CHANGE BULLETIN 06

F.G.A. No. 21003

ROOMS TO GO – OFFICE RENOVATION & EXPANSION

June 12, 2023

SHEET NUMBER
M1.10D

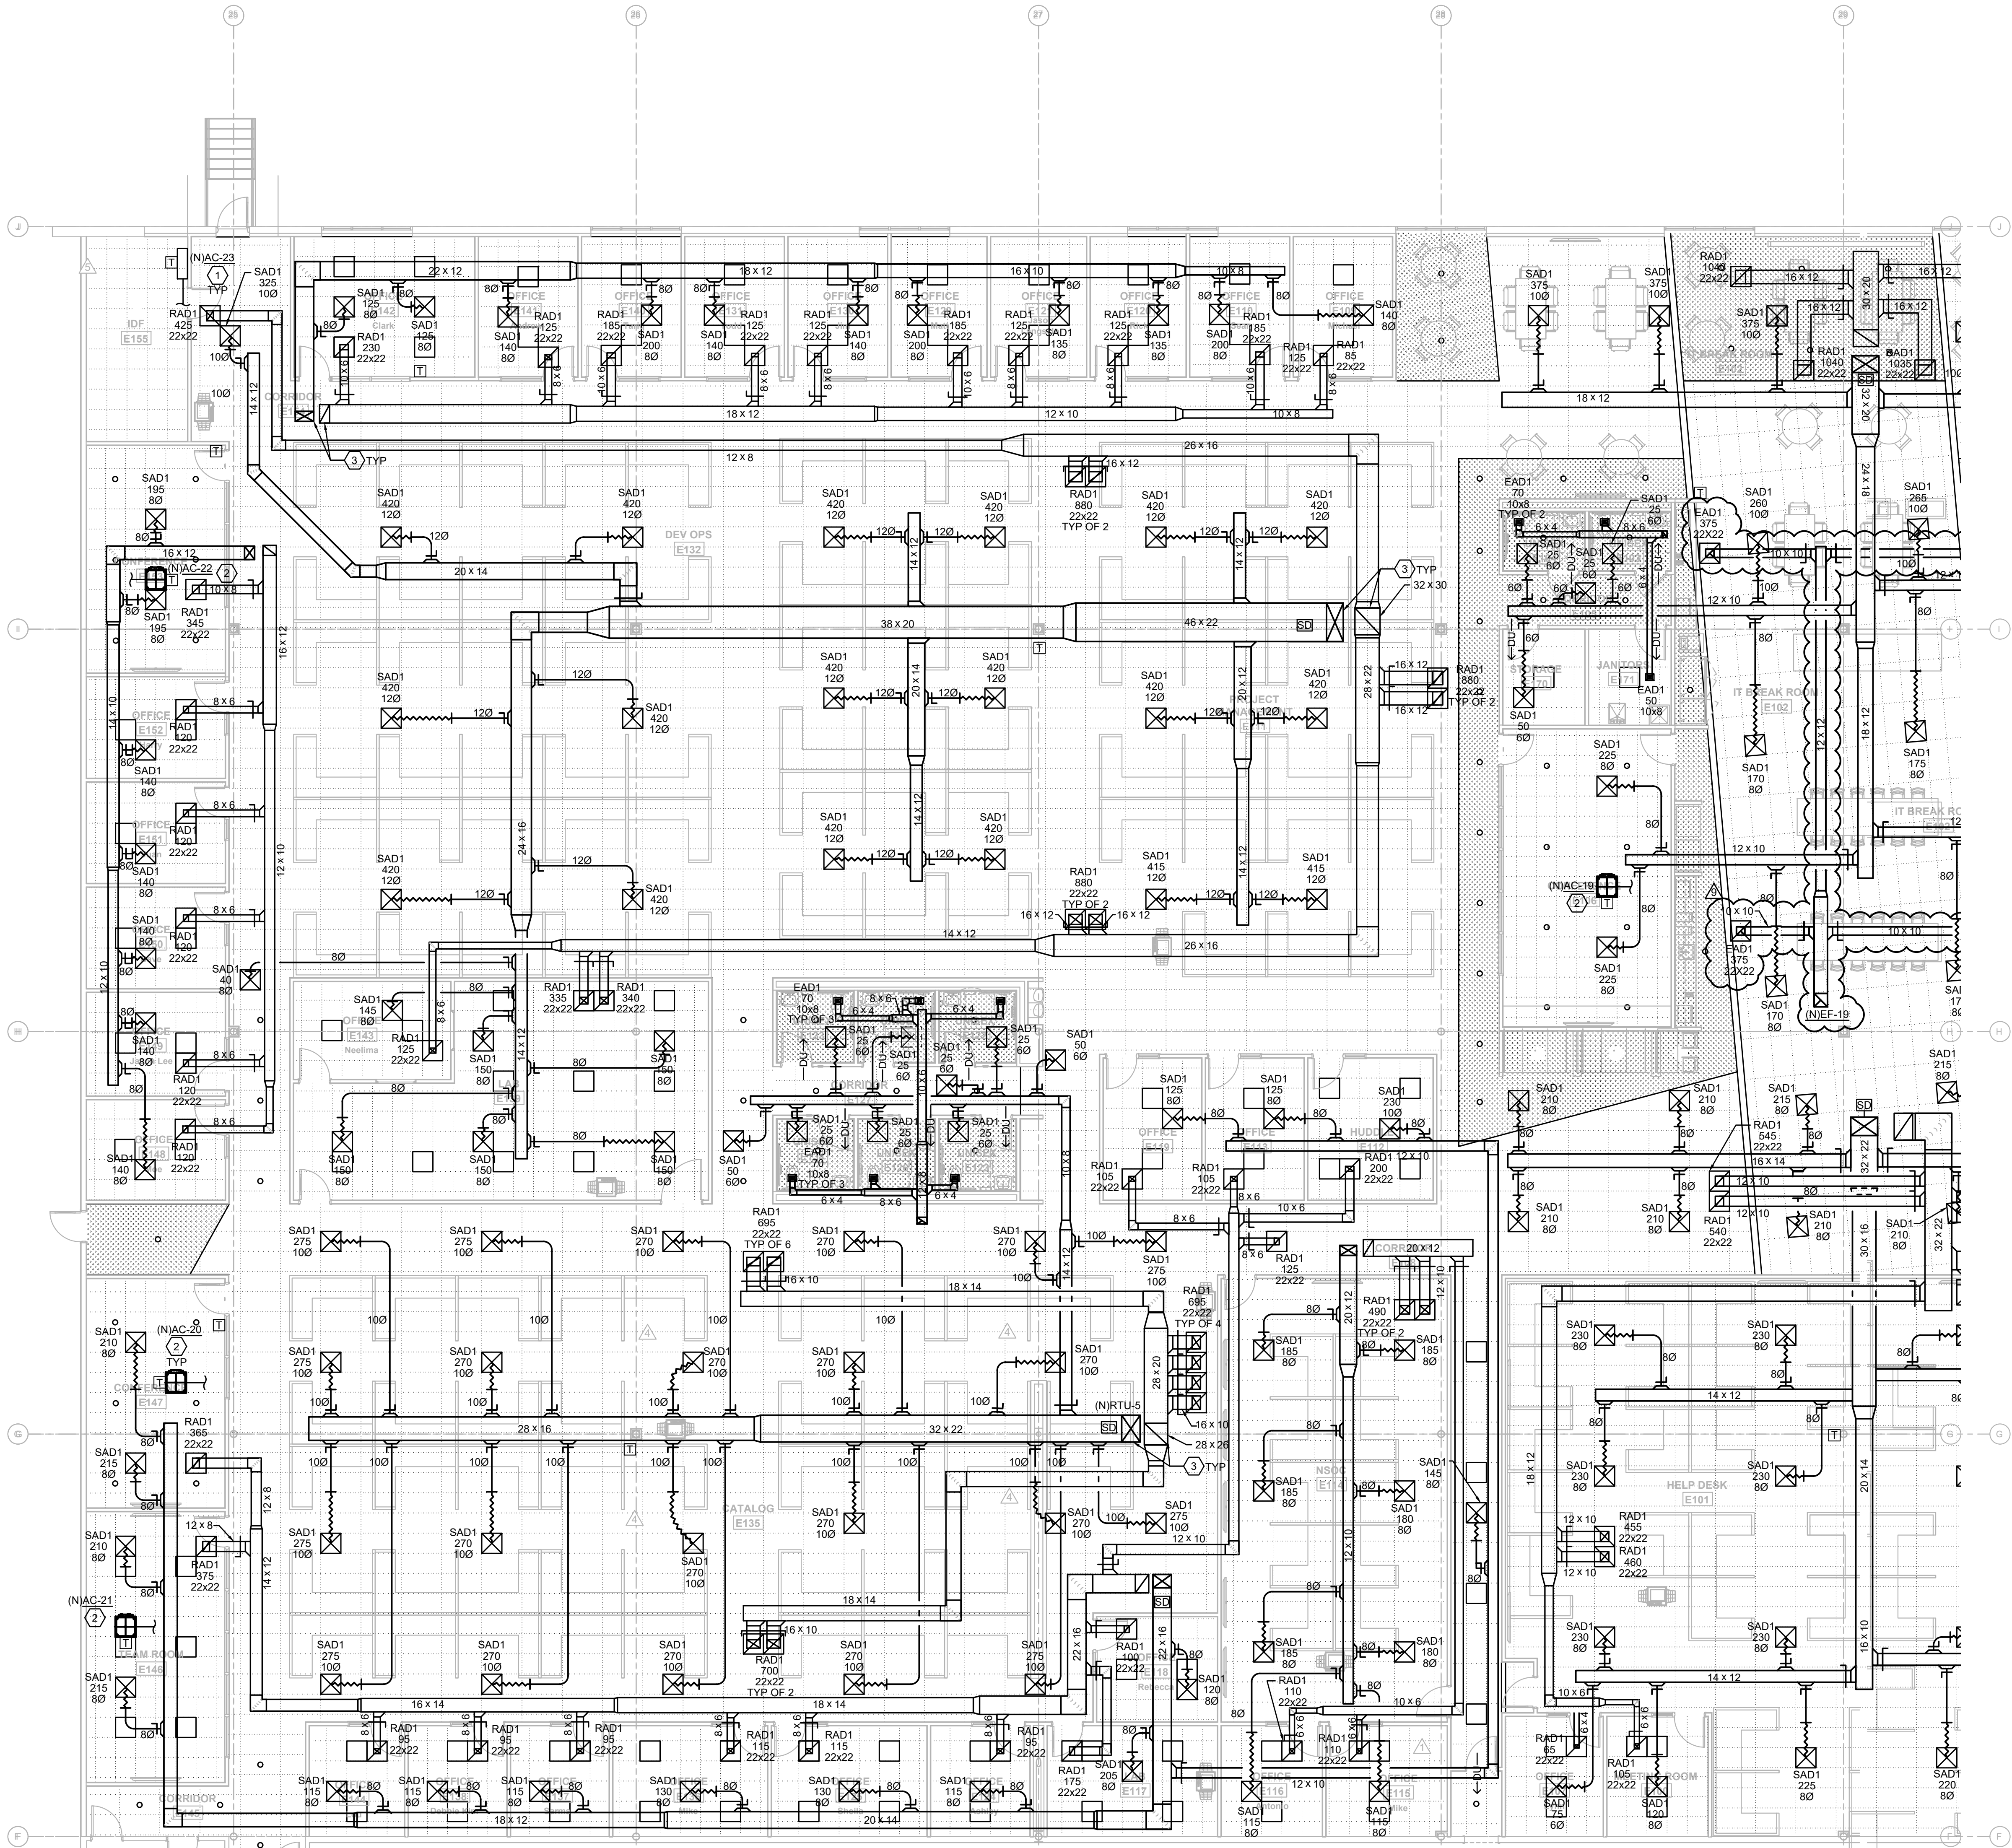
- Item 8: Refer to Sheet M1.10D - HVAC Plan – D
- Add roof mounted exhaust fans (N)EF-15 through (N)EF-23 and associated exhaust ductwork and grilles to all the breakrooms and pantries.

SHEET NUMBER
M1.20

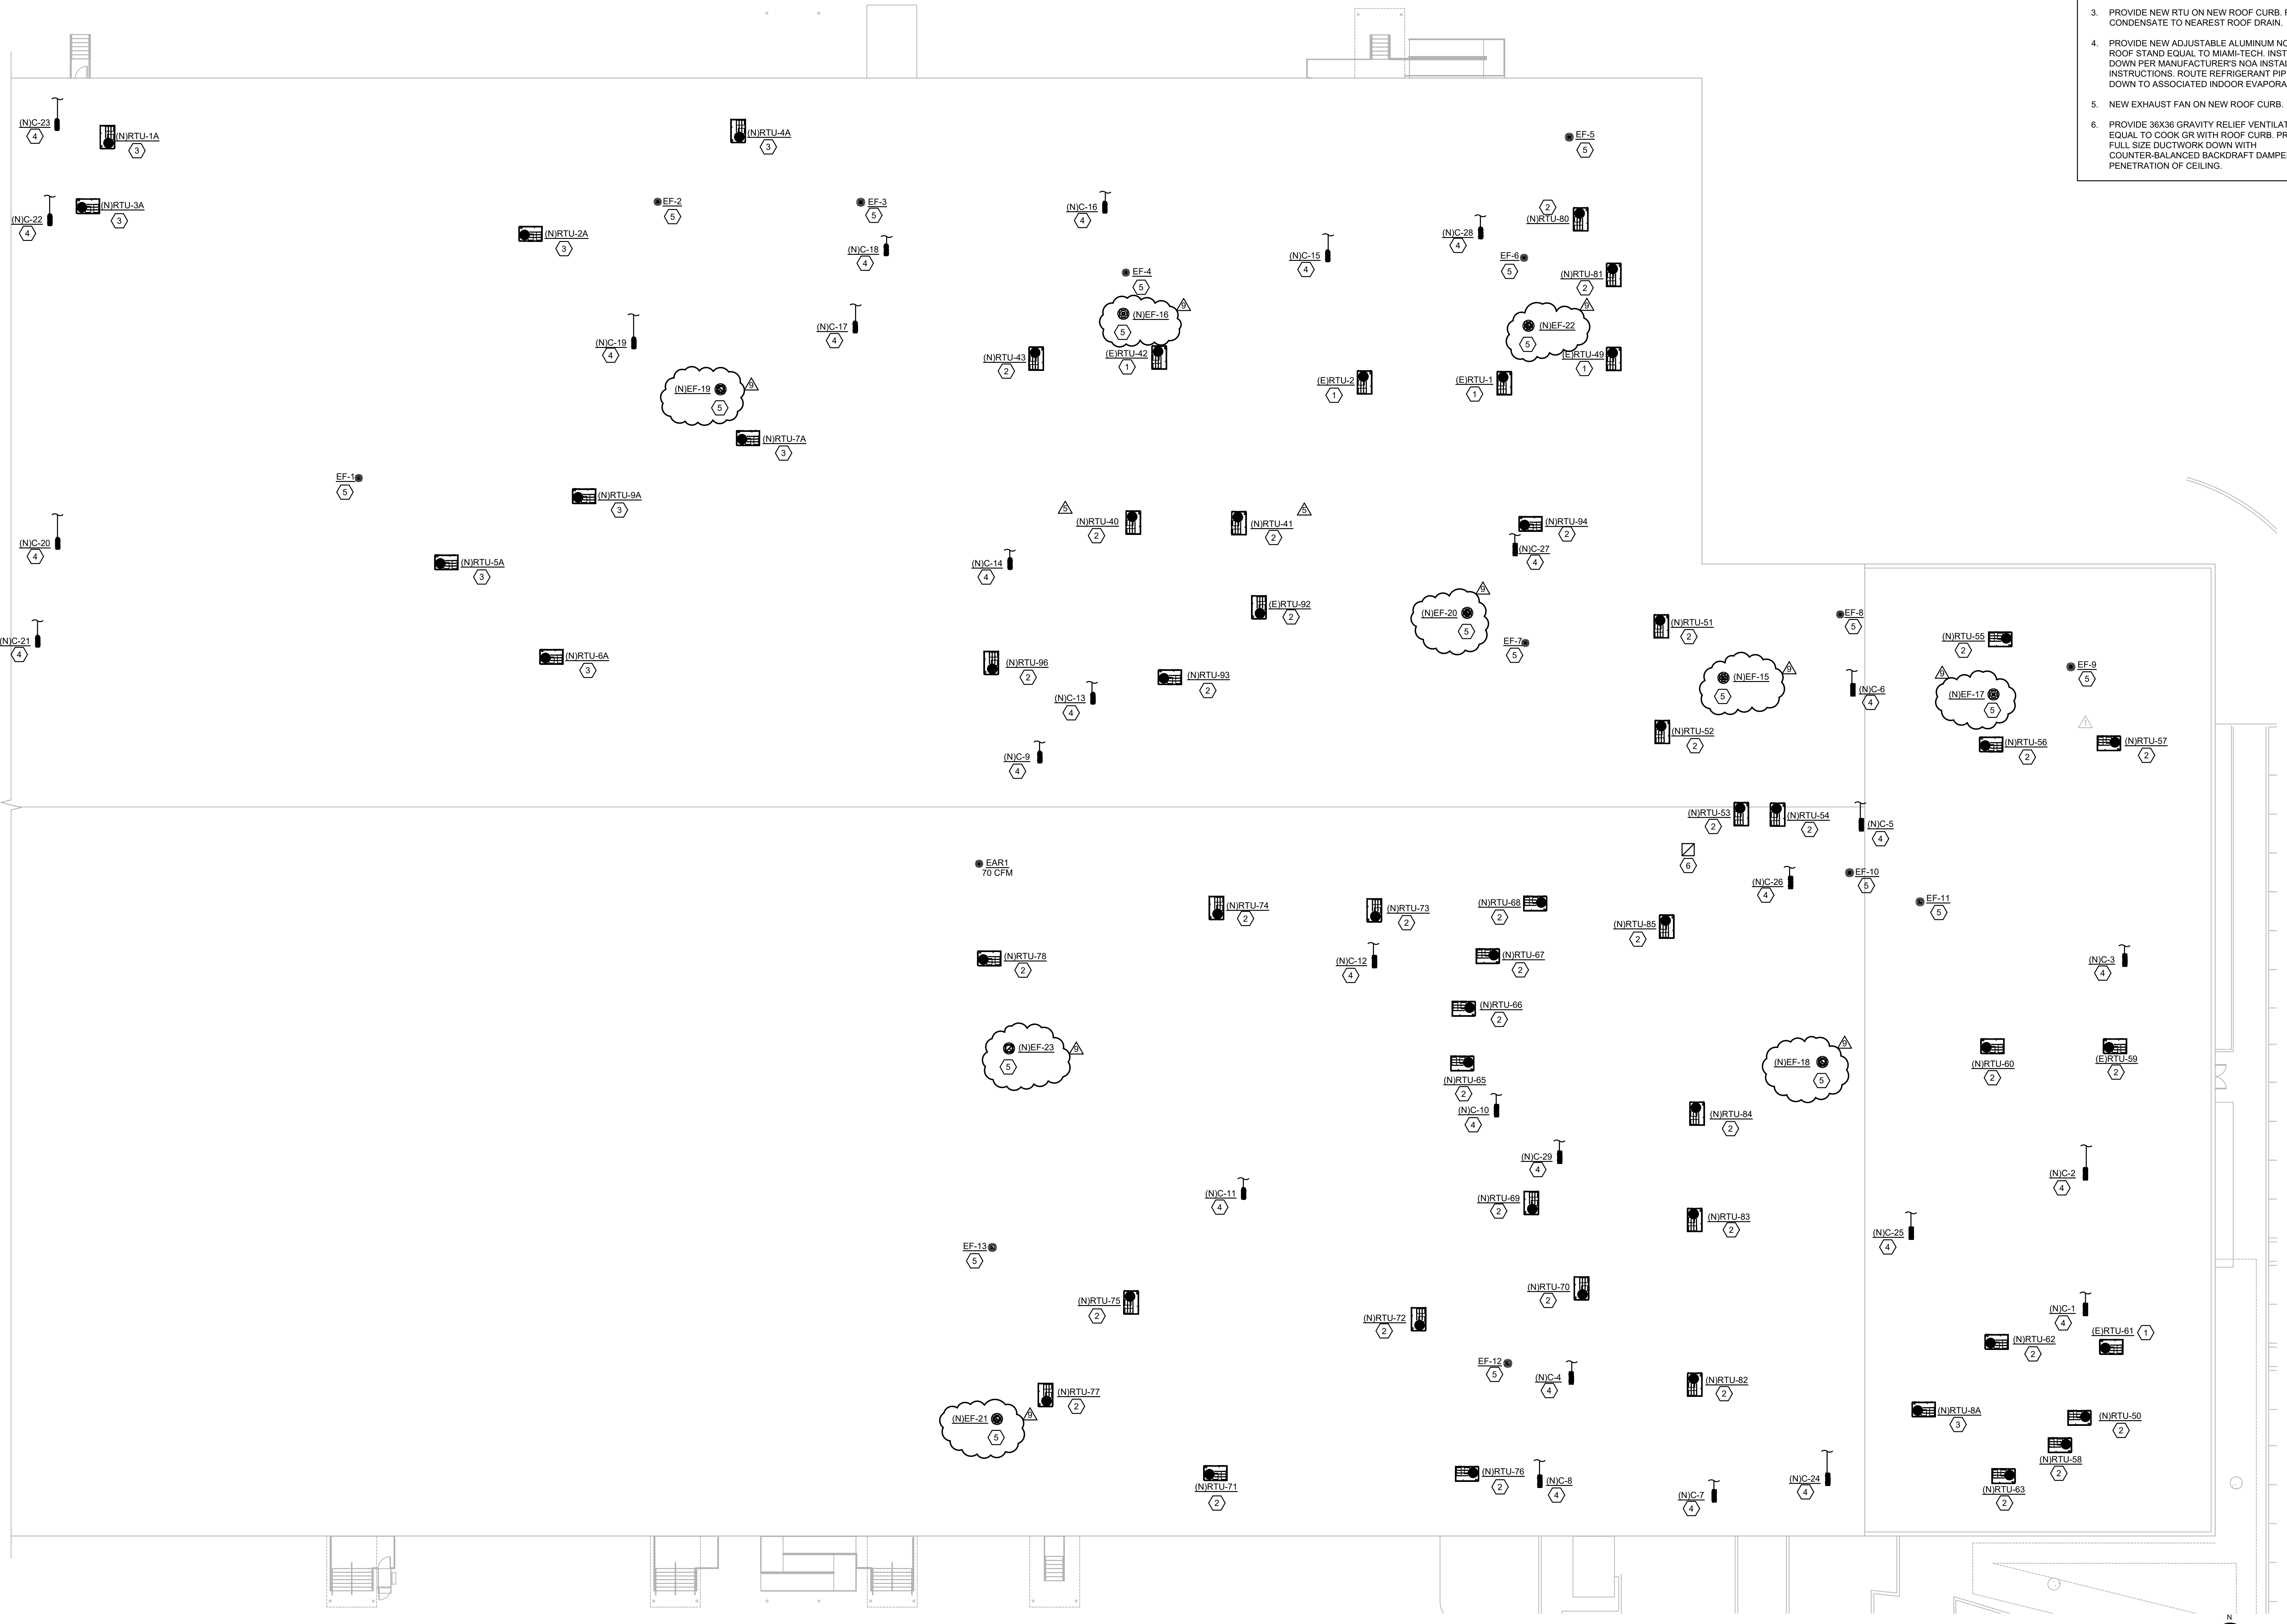
- Item 10: Refer to Sheet M1.20 - HVAC Roof Plan
- Add roof mounted exhaust fans (N)EF-15 through (N)EF-23 and associated exhaust ductwork and grilles to all the breakrooms and pantries.

SHEET NUMBER
E.10B

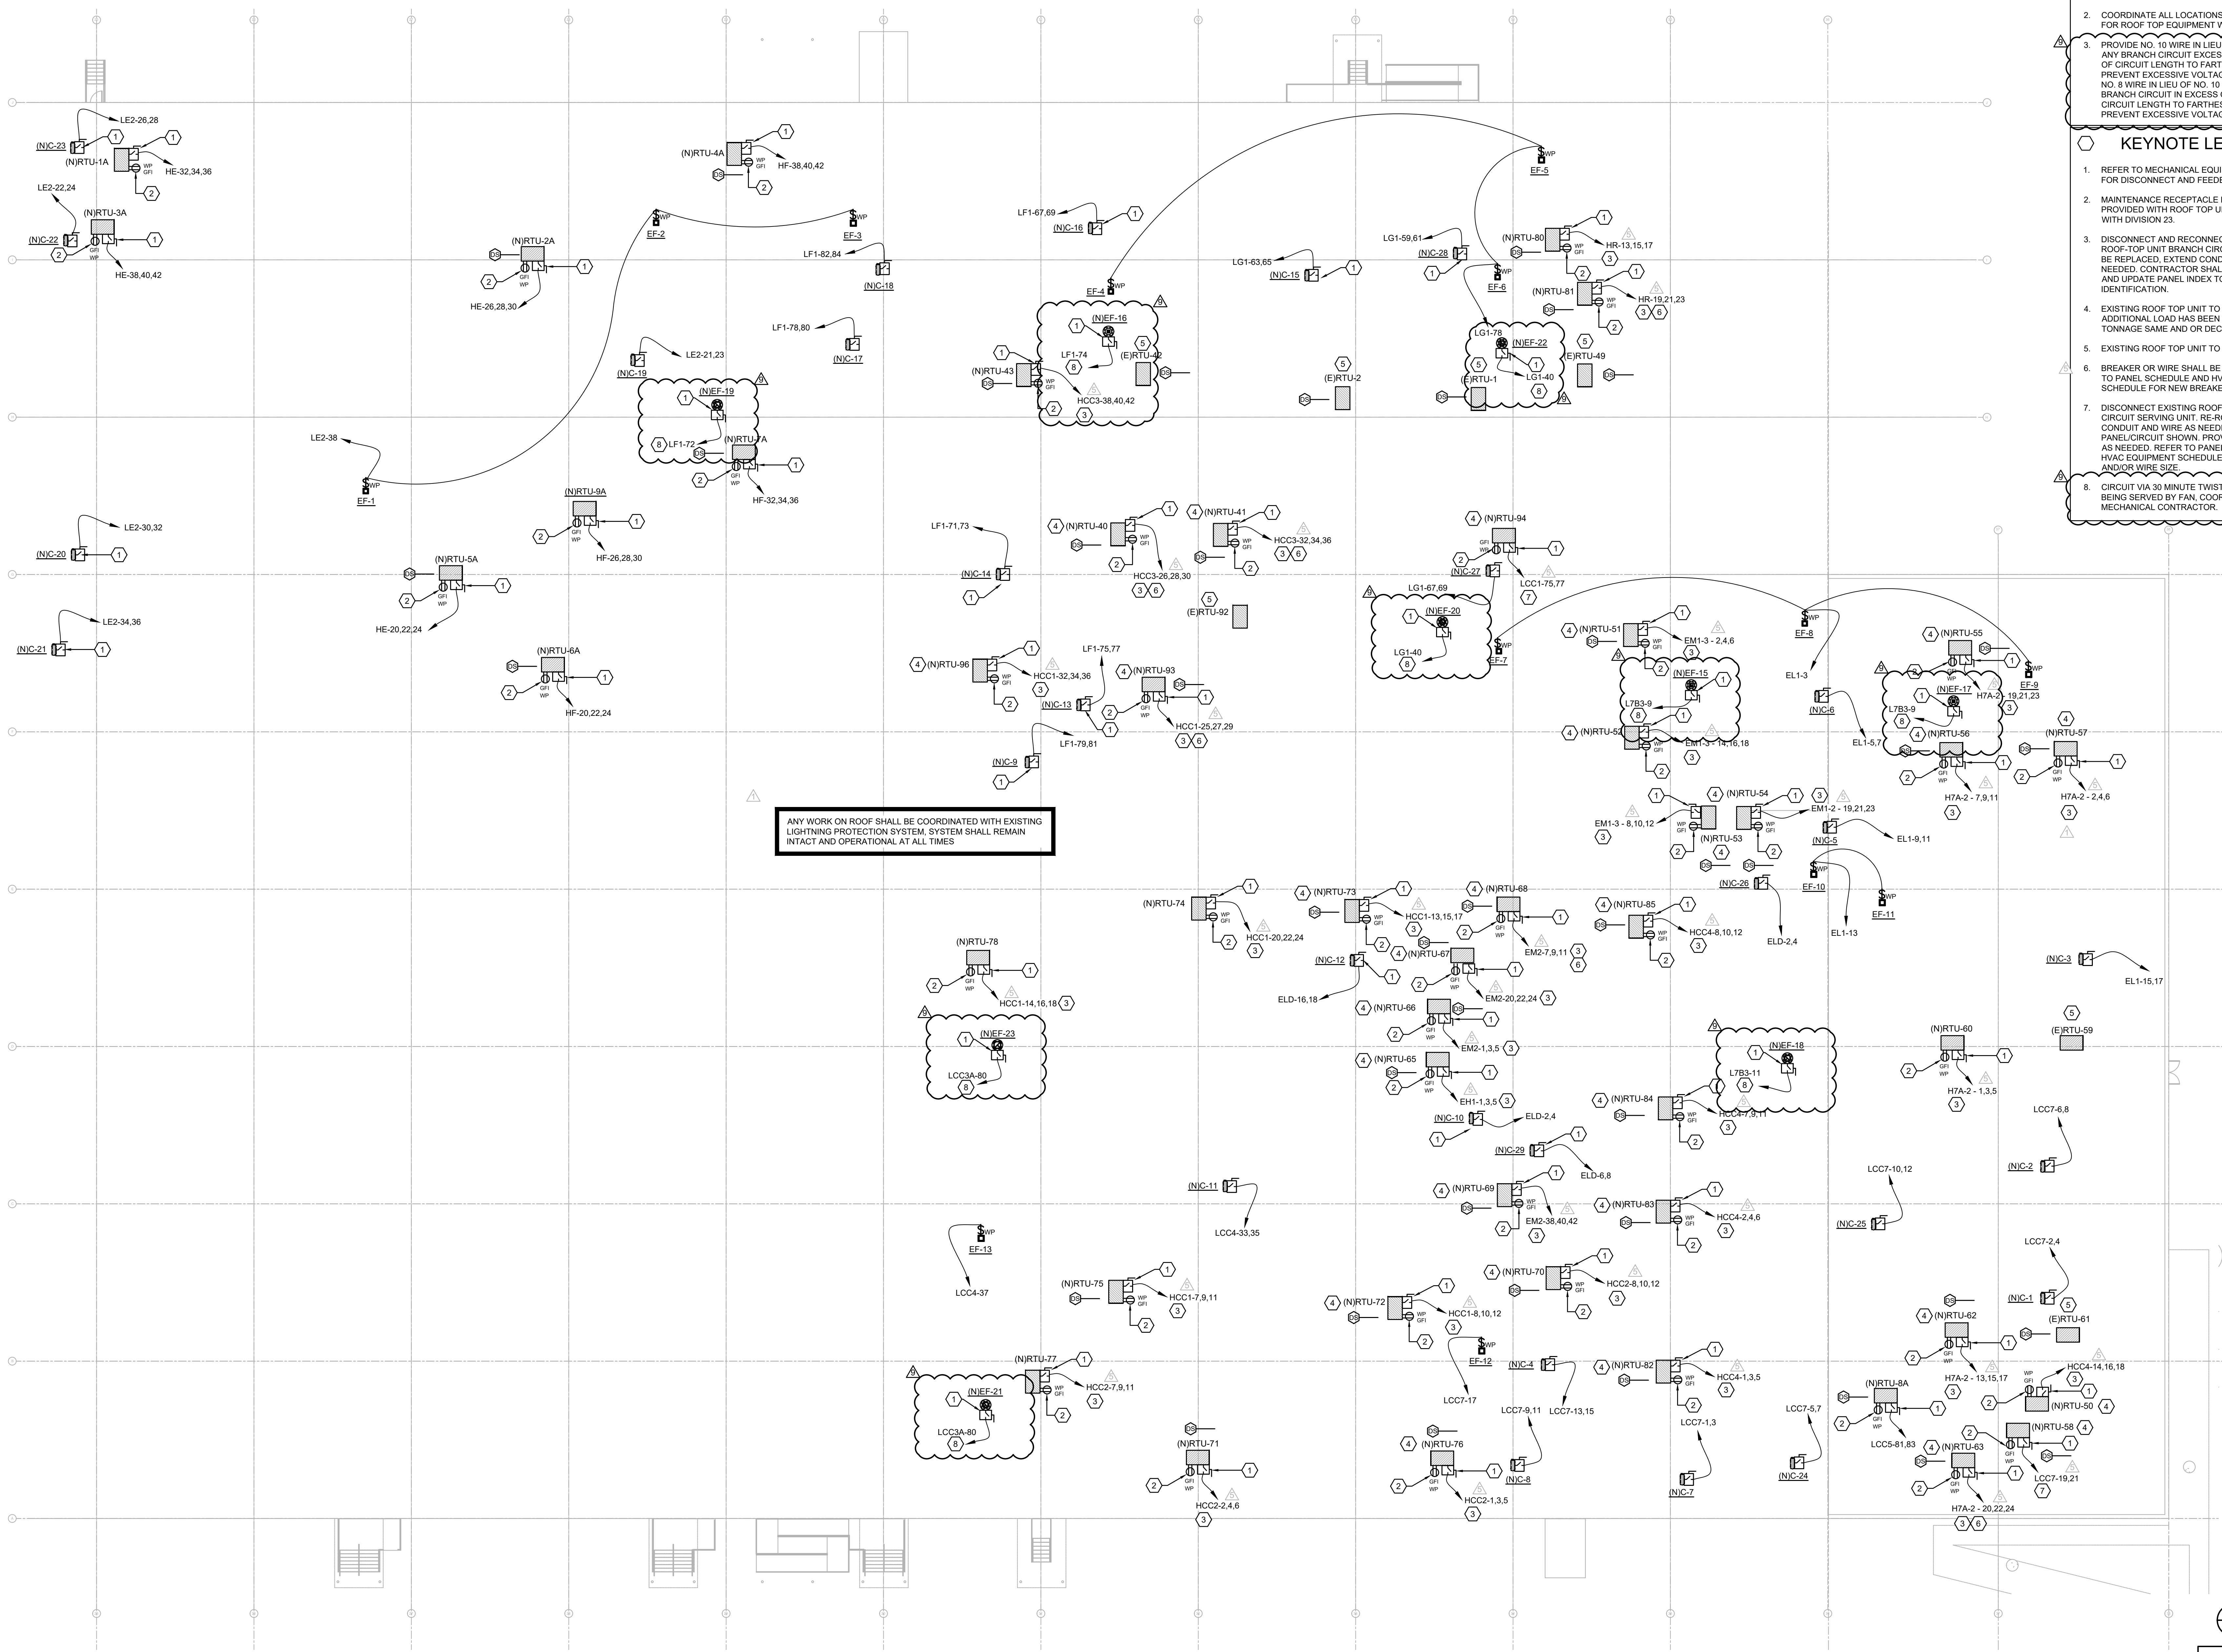
- Item 12: Refer to Sheet E1.10B - Power Plan – B
- Add wall back for HR office B153.
- Item 13: Refer to Sheet E1.20 – Power Roof Plan
- Add nine (9) roof exhaust fans and note for voltage drop.
